**BANKING
DIAGRAM
SHEET 7**

PROJECT:	DOVER-STRATTON	PROJECT NO.:	STP 2214(I)S
DESIGN FILE NAME:	/pave/99bi80/pbi80.dgn	PLOT DATE:	24-MAY-2007
IPARM FILE NAME:	pbi80bd07.i	SURVEY DATE:	5/00
SURVEYED BY:	CLD ENGINEERS, INC	DRAWN BY:	PTS
SQUAD LEADER:	WRH	SHEET:	37 OF 49

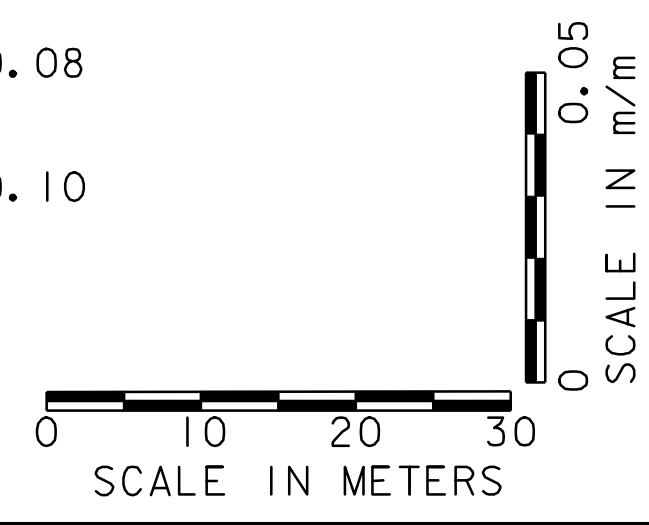
THE GRADES WERE ADJUSTED TO MEET FIELD CONDITIONS
